SOM Review

Copy of Property	
Created	@Jan 7, 2021 3:51 PM
DOC	review comments .docx
Property 1	
Tags

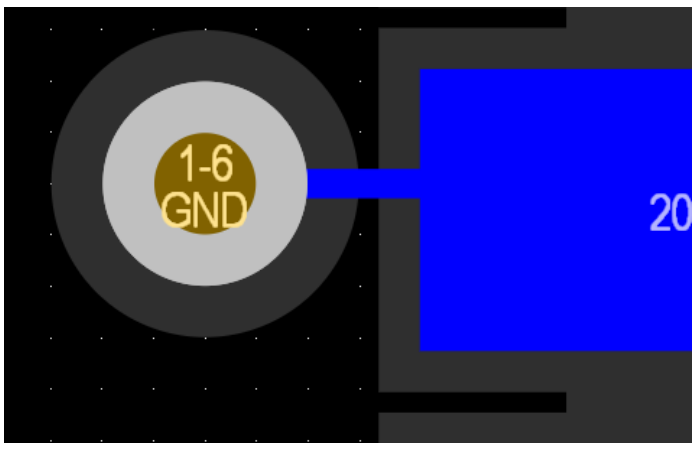
why there are two grounds vias.png

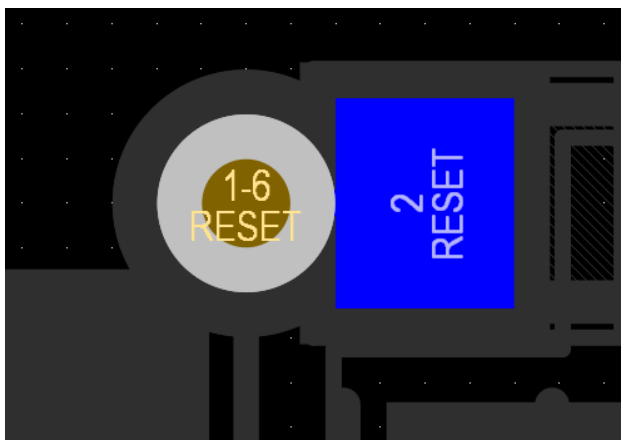
why tracks are so tiny for the VDDMP.png

why this track is so tiny.png

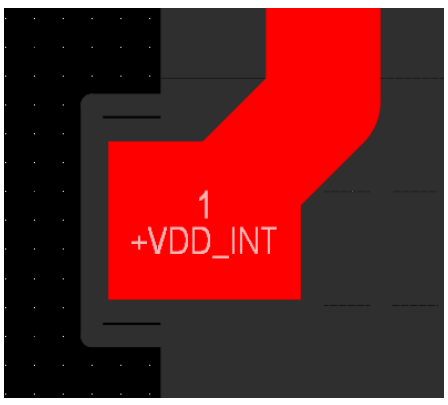
check this too.png

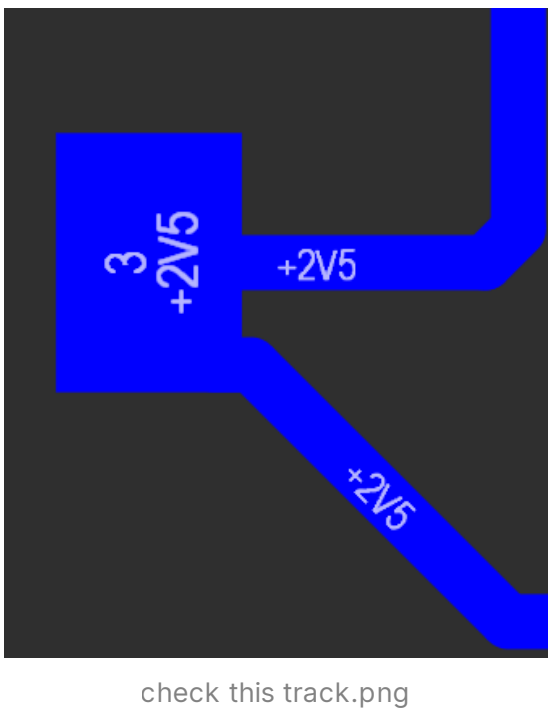
Why this track is done like that.png

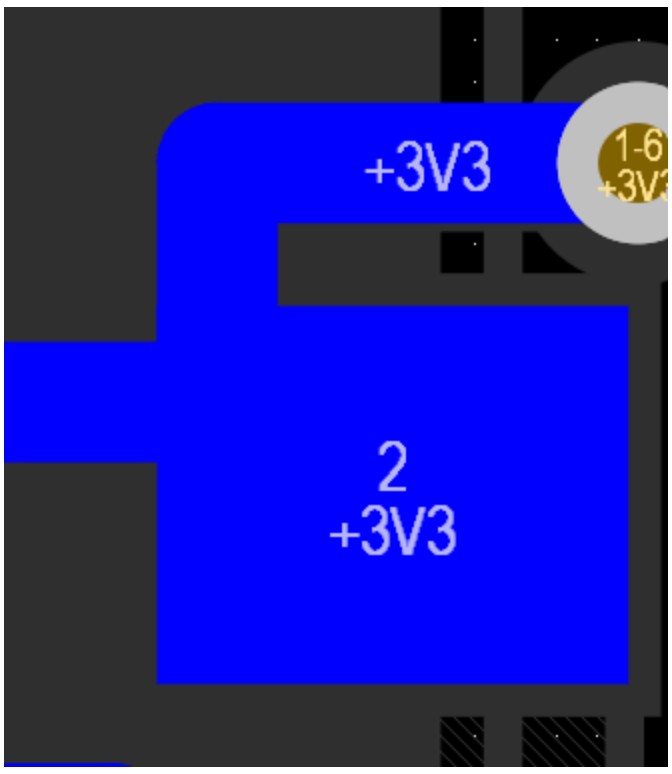
check this track.png
